SAN JUAN RIVER BASIN
ADJUDICATION

La Plata River Section

**ORDER CORRECTING MISTAKES REGARDING MAP ERRORS IN TWENTY-ONE
CONSENT ORDERS IN THE LA PLATA ADJUDICATION**

Tract Number
SJLP-003-0018B

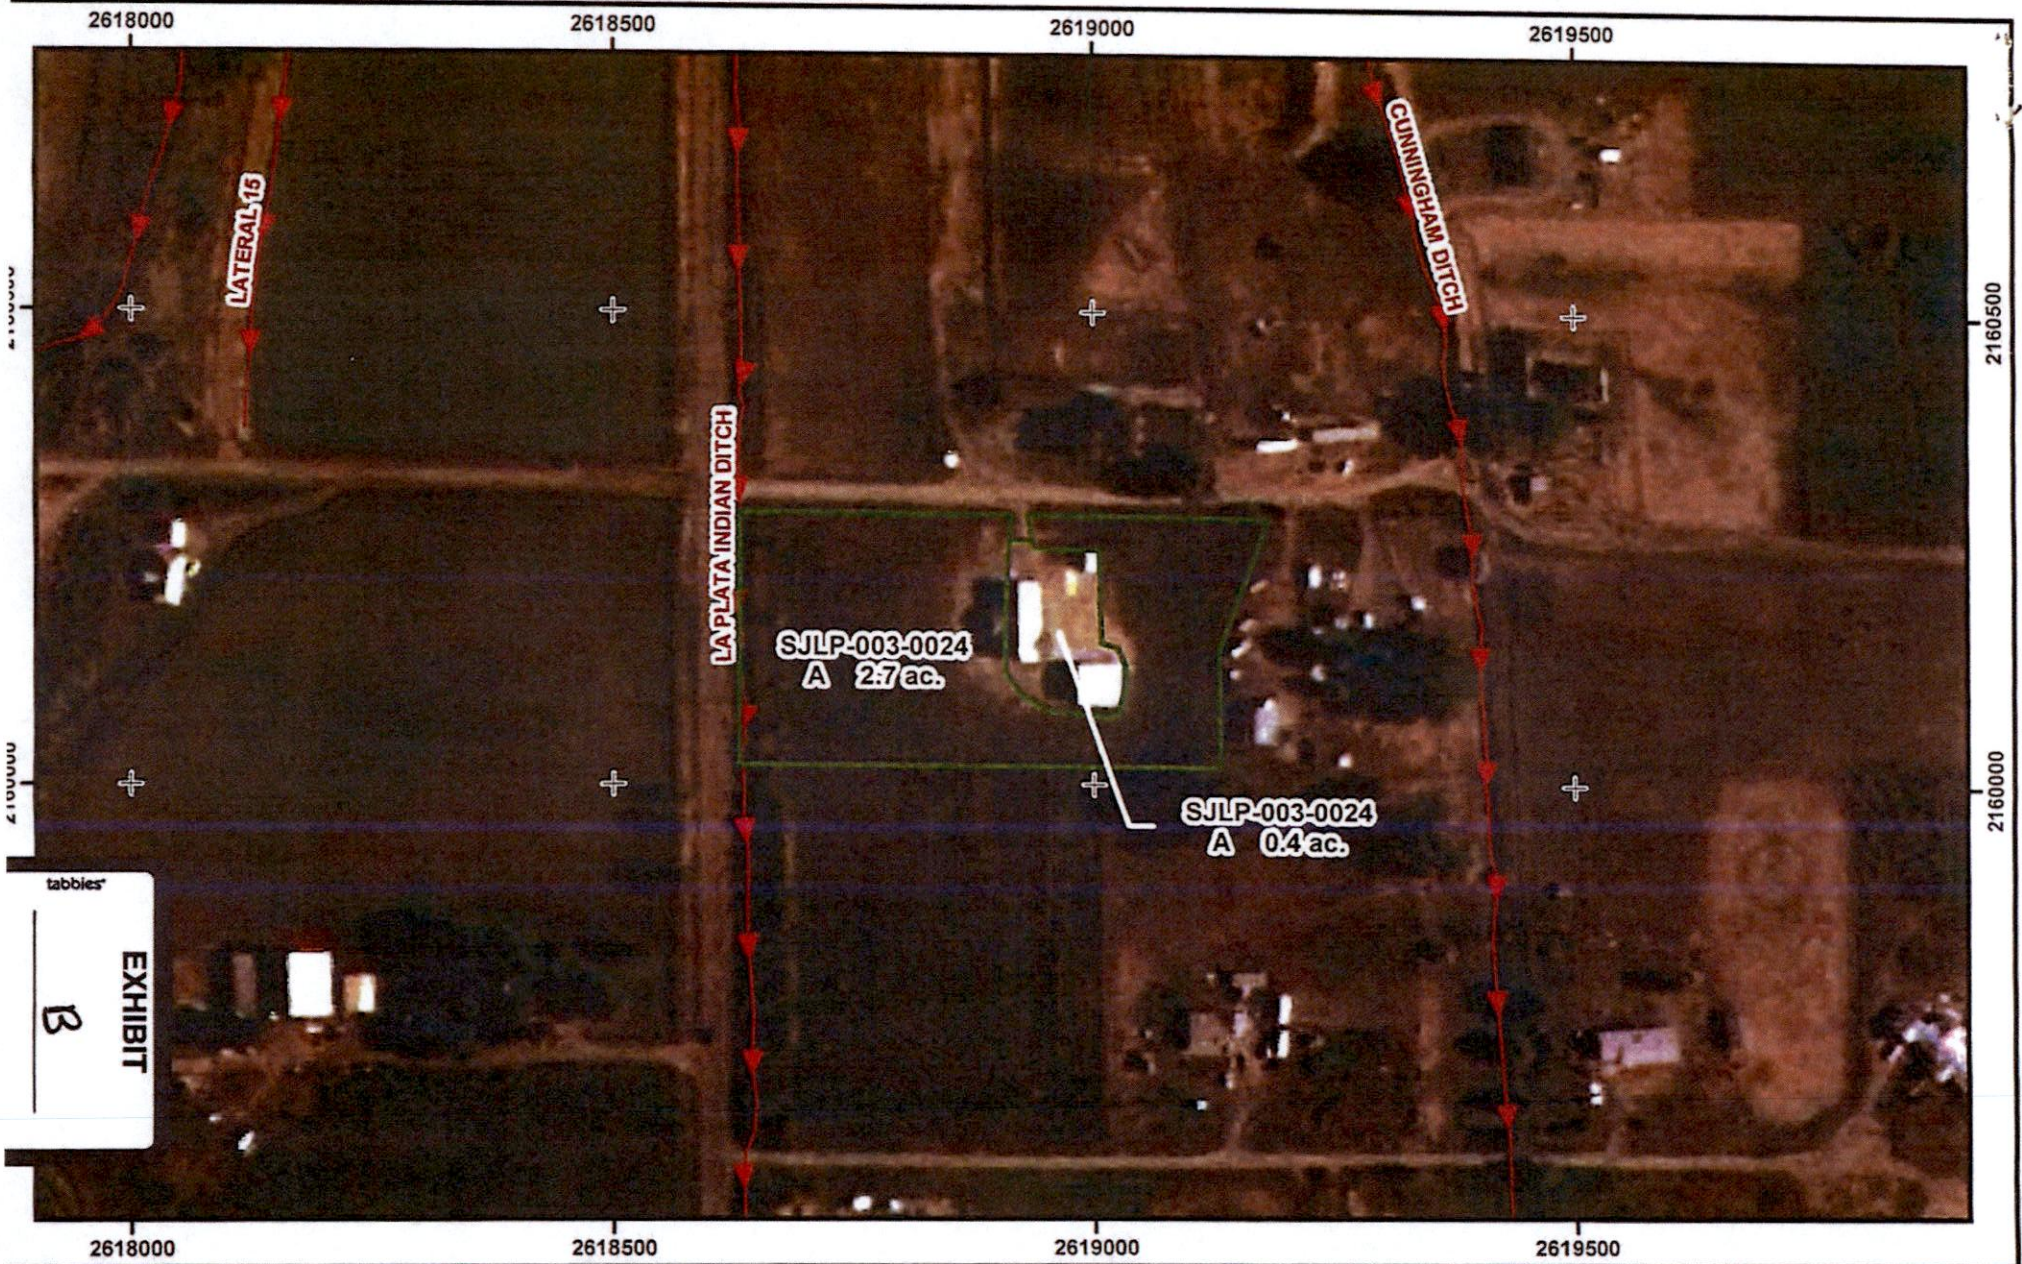
Owner & Address	Subfile No.	Date Subfile Order Entered	Court No.	Subfile Order Section with Error	Error	Change Needed
R. Ranch Cattle Co. Inc. P.O. Box 1936 Bloomfield, NM 87413	003-0018-B	Implied Consent 5/26/2015	AF-01-529	A	Heading A: No Right Acreage in Subfile Order is 3.6 acres. No Right Polygon A on map is 3.61 acres.	Corrected map attached as Exhibit A. No Right Polygon A has been corrected to 3.6 acres.
Melissa Montoya Jason T. Montoya 6 Rd. 1273 La Plata, NM 87418	003-0024	10/16/2008	AF-01-95	A	Heading A: Irrigated Acreage in Subfile Order is 3.1 acres. Irrigated Polygons A on map equal 3.12 acres.	Corrected map attached as Exhibit B. Irrigated Polygons A have been corrected to 3.1 acres.
Hamblin Farms Inc. by G. Elbert Hamblin 1380 Highway 170 La Plata, NM 87418	003-0046	Amended 12/29/2009	AF-01-117	B	Heading B: Acreage in Subfile Order is 63.4. Acreage for Polygon B on map is 66.1 acres. Map is incorrect.	Corrected map attached as Exhibit C. Polygon B has been corrected to 63.4 acres.

Tract Number
SJLP-004-0052

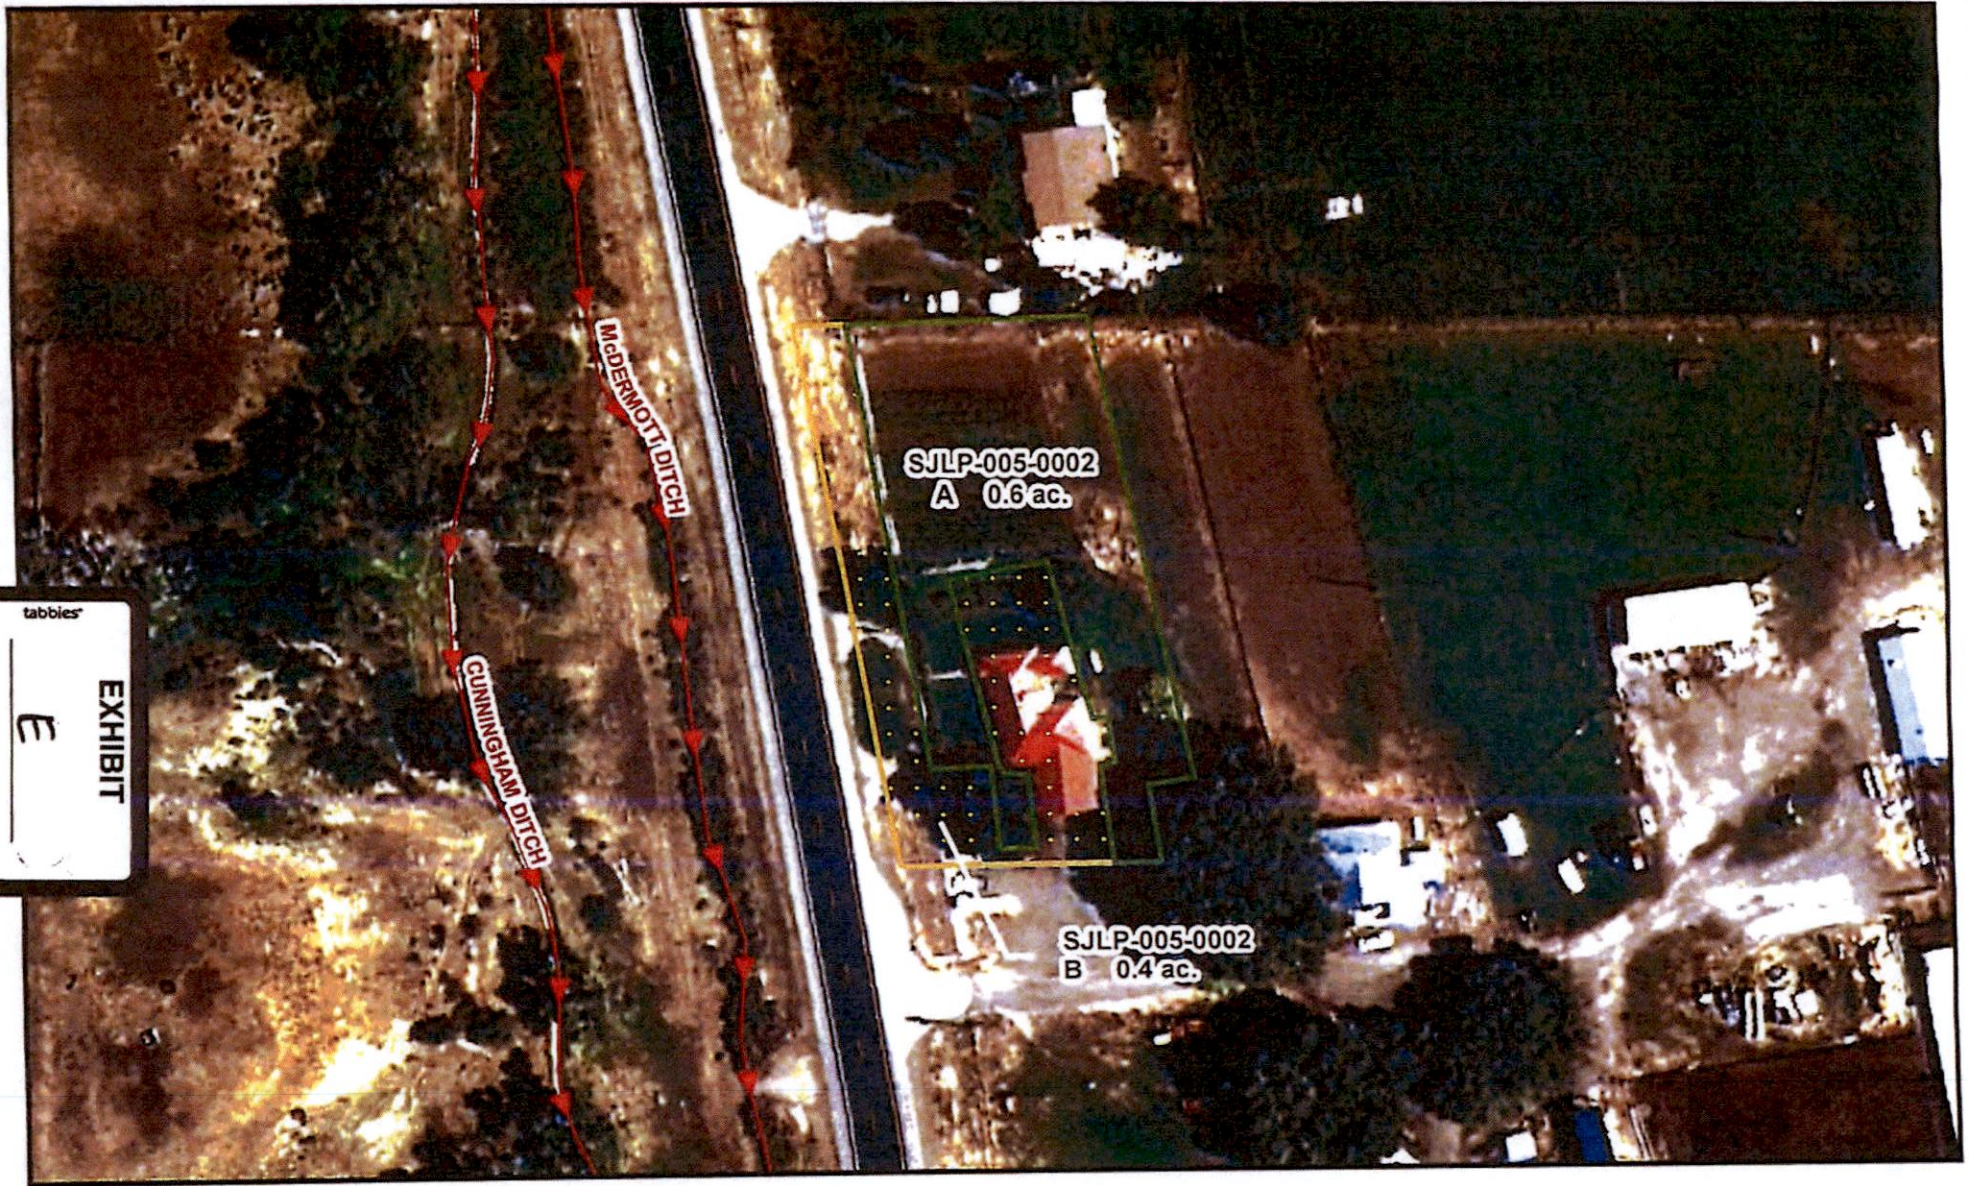
<p>Thelma Faye Nickles Lloyd L. Nickles 1394 Highway 170 La Plata, NM 87418</p>	<p>004-0052</p>	<p>7/21/2011</p>	<p>AF-01-488</p>	<p>A, B, C</p>	<p>Two dissimilar maps are included in OSE records. 2009 map includes Polygon D which is not mentioned in the Subfile Order. 2017 map is correct.</p>	<p>Correct map is attached as Exhibit D. The acreages for Polygons A, B, and C are correct and Polygon D is not on the map.</p>
<p>Nila L. Hamblin G. Elbert Hamblin 1380 Highway 170 La Plata, NM 87418</p>	<p>005-0002</p>	<p>12/29/2009</p>	<p>AF-01-140</p>	<p>A, B</p>	<p>Two dissimilar maps are included in OSE records. Acreage on map dated 2/16/2009 does match acreage in Subfile Order showing Polygon A as 0.6 Irrigated acres and Polygon B as 0.4 No Right acres. Acreage on map dated 9/1/2009 does not match Subfile Order, showing Polygon A as 0.7 Irrigated acres, and Polygon B as 0.3 No Right acres.</p>	<p>Correct map attached as Exhibit E. Correct acreage shows Polygon A as 0.6 Irrigated acres, and Polygon B as 0.4 No Right acres.</p>

Tract Number
SJLP-005-0002
 McDermott Ditch
 November 22, 2023

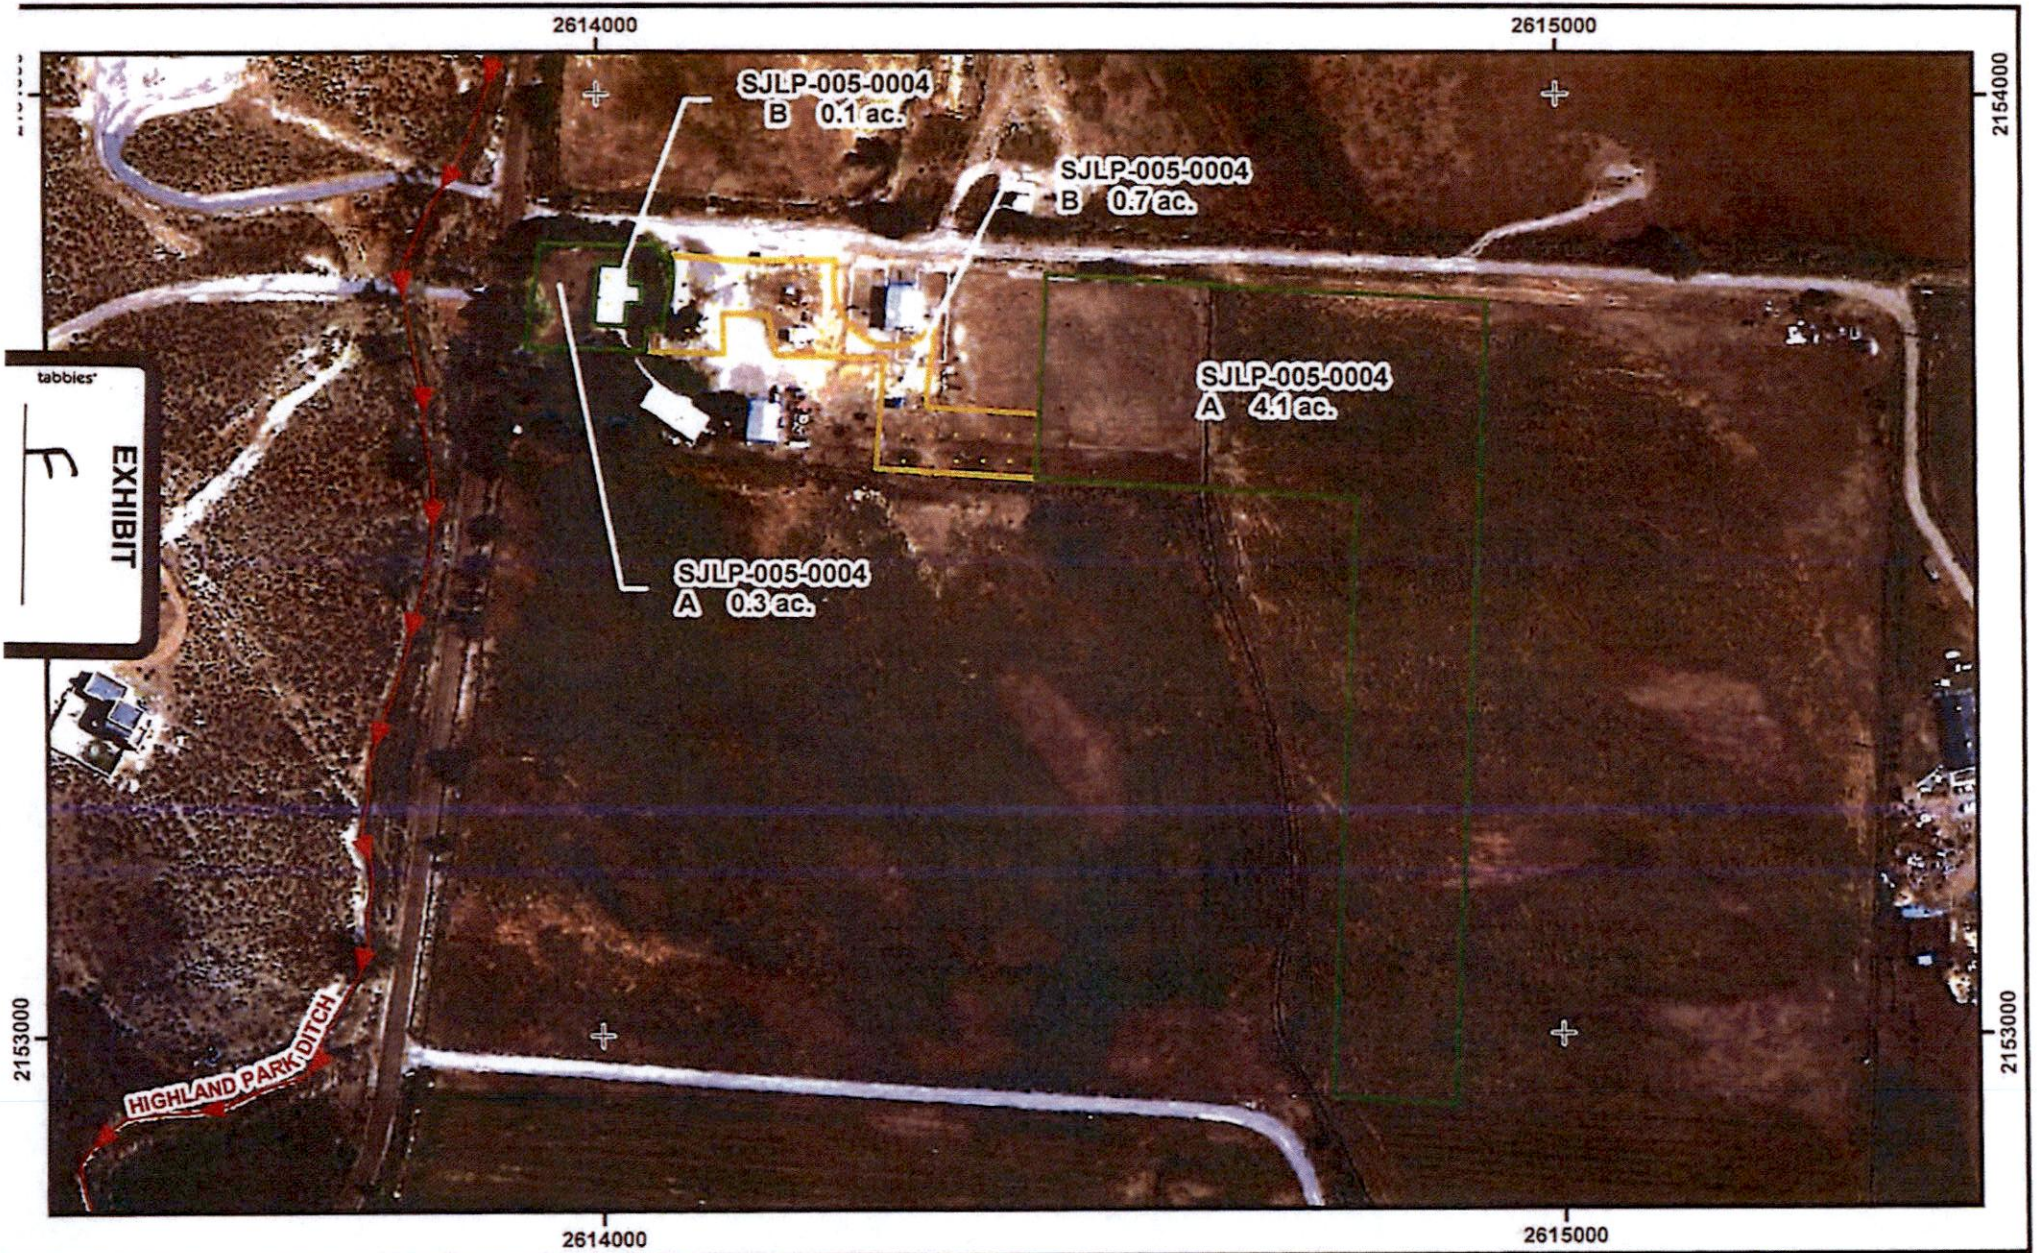
Sean Washburn Dawnett L. Washburn 316 Road 1191 La Plata, NM 87418	005-0004	8/11/2009	AF-01-185	A	Heading A: Subfile Order states acreage is 4.4 acres while Polygon A on map is showing 4.5 acres of irrigation. 4.4 acres is correct.	Corrected map attached as Exhibit F. Polygon A acreage is corrected to 4.4 acres.
Charlene Jackson Clyde David Jackson Road 1191 #318 La Plata, NM 87418 Sean Washburn Dawnett L. Washburn 316 Road 1191 La Plata, NM 87418	005-0005	8/11/2009	AF-01-186	A, B	Heading A: Subfile Order states acreage is 10.6 acres while Polygon A on map is showing 10.1 acres of irrigation. Heading B: Subfile Order states acreage is 0.5 acres while Polygon B on map is showing 1.0 acre of No Right.	Corrected map attached as Exhibit G. Polygon A is corrected to 10.6 acres. Polygon B is corrected to 0.5 acres.
Heather Anthony Matthew Anthony PO Box 441 La Plata, NM 87418	005-0038	8/11/2009	AF-01-213	A, B	Heading A: Acreage is 8.0 in Subfile Order and 7.3 acres on map. Heading B: No Right acreage is 1.1 in Subfile Order and 1.5 acre on map.	Corrected map attached as Exhibit H. Polygon A is corrected to 8.0 acres. Polygon B is corrected to 1.1 acres.

Tract Number
SJLP-008-0023
 Jackson Ditch
 Amended
 November 28, 2023

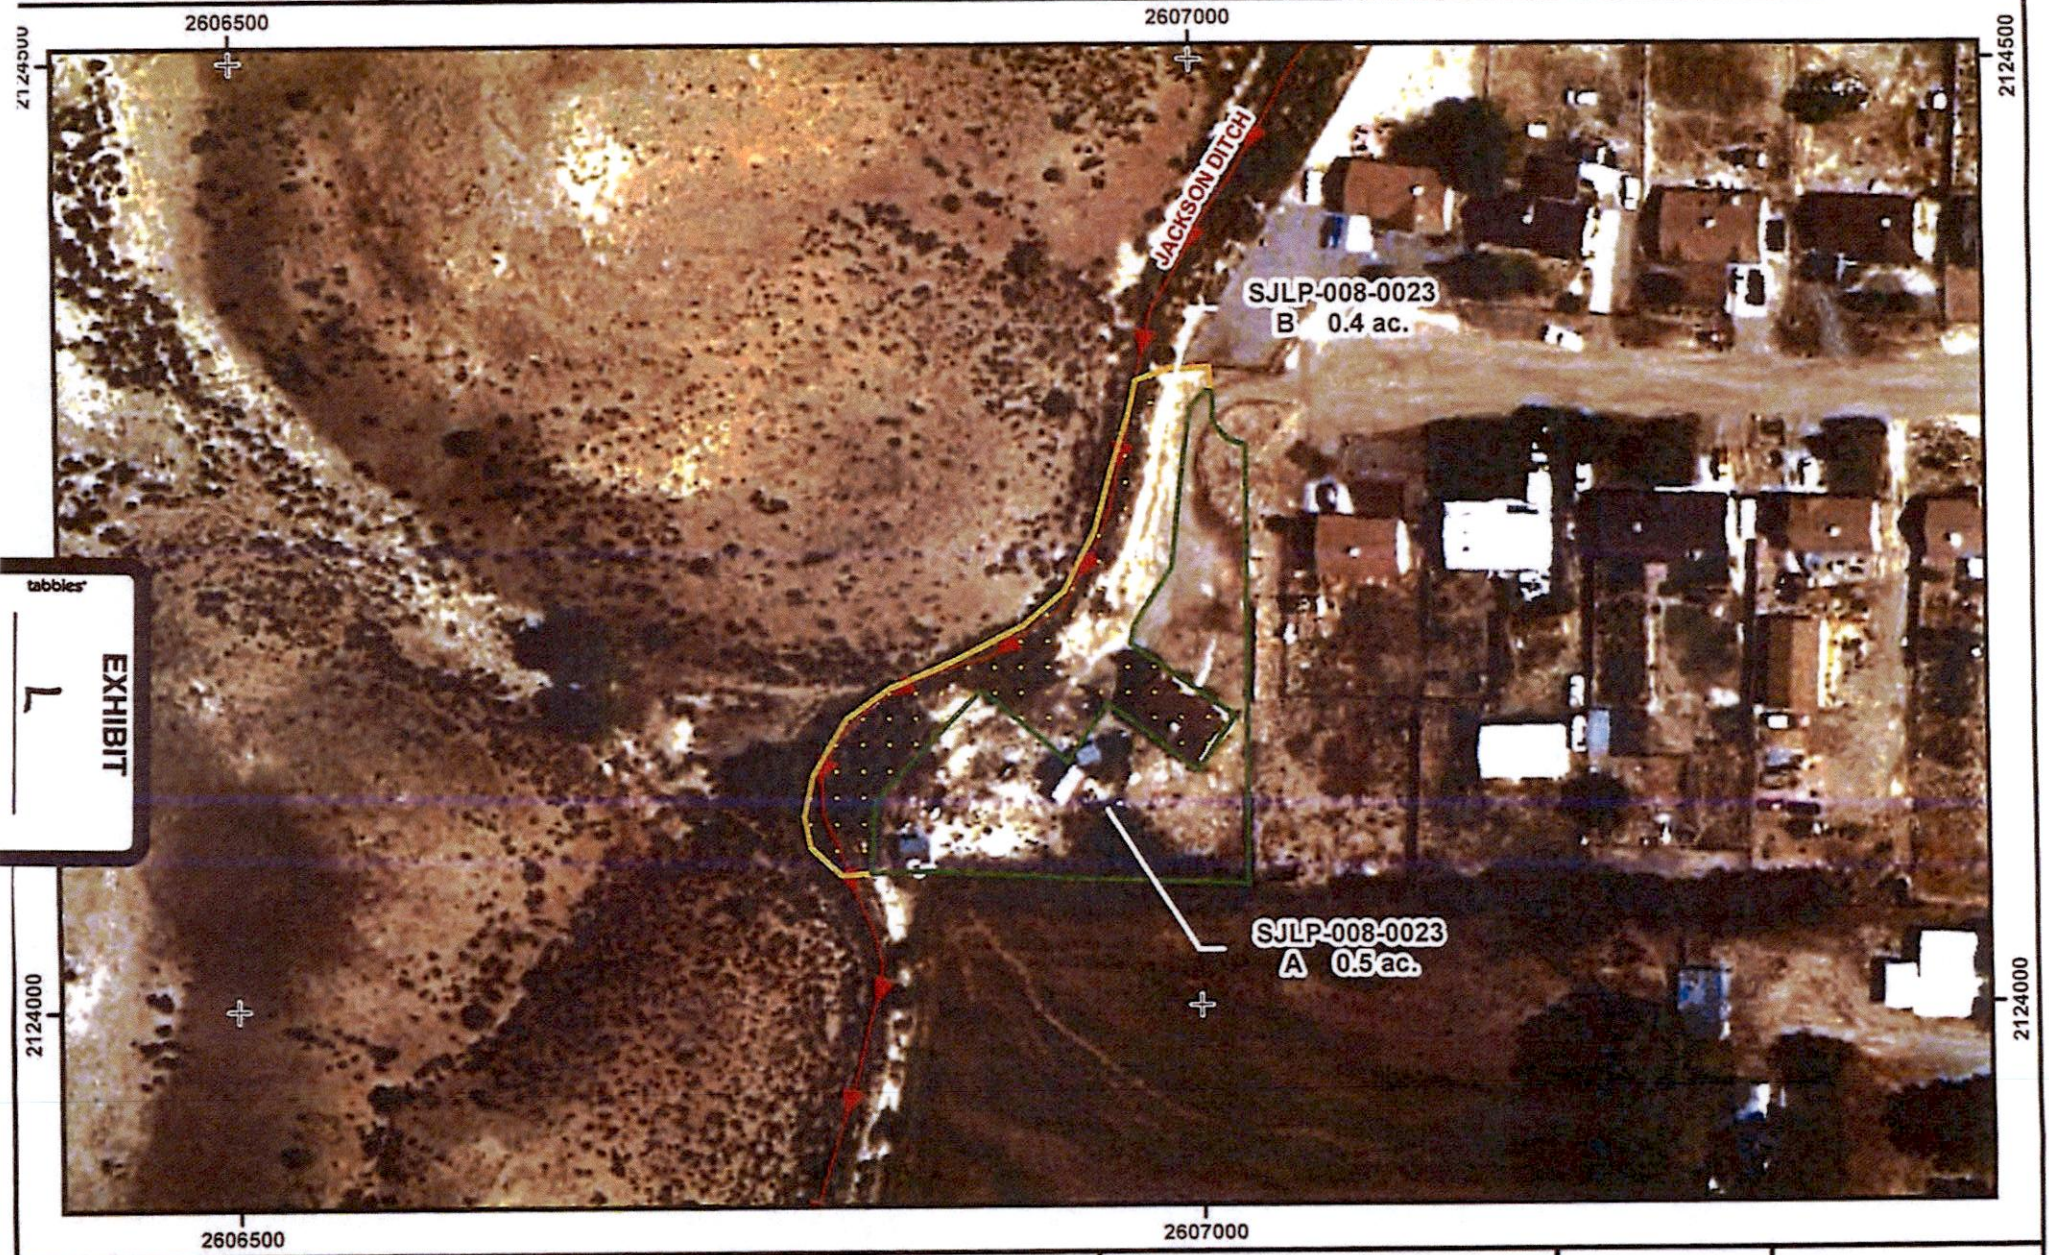
<p>Stephen P. Mathews Linda J. Mathews 15 Road 1738 Farmington, NM 87401</p>	<p>008-0023</p>	<p>4/30/2014</p>	<p>AF-01-532</p>	<p>A, B</p>	<p>Two dissimilar maps are included in OSE records.</p> <p>The 2008 map is incorrect, the 2013 map, which was filed with the Court, is correct.</p>	<p>Correct map attached as Exhibit L.</p> <p>Map matches Subfile Order with Polygon A as 0.5 Irrigated acres, and Polygon B as 0.4 No Right acres.</p>
<p>Emily S. Rascoe 11 County Road 1764 Farmington, NM 87401</p> <p>John Edward Rascoe 11 County Road 1764 Farmington, NM 87401</p>	<p>008-0035-A</p>	<p>12/2/2014</p>	<p>AF-01-373</p>	<p>A, B</p>	<p>No Right symbology in Polygon B on map is atypical. Consists of very tiny dots, some of which appear to be green.</p>	<p>Corrected map attached as Exhibit M.</p> <p>Polygon B is showing correct No Right symbology.</p>
<p>Stephen L. Johnson Jeanne Johnson PO Box 2657 Farmington, NM 87499</p>	<p>008-0069</p>	<p>11/22/2011</p>	<p>AF-01-403</p>	<p>A</p>	<p>Map ascribes incorrect acreages to all A polygons.</p> <p>Polygon A incorrectly states 1.4 acres.</p> <p>Polygon A incorrectly states 0.2 acre.</p>	<p>Corrected map attached as Exhibit N.</p> <p>Polygon A is corrected to 1.5 acres.</p> <p>Polygon A is corrected to 0.1 acre.</p>
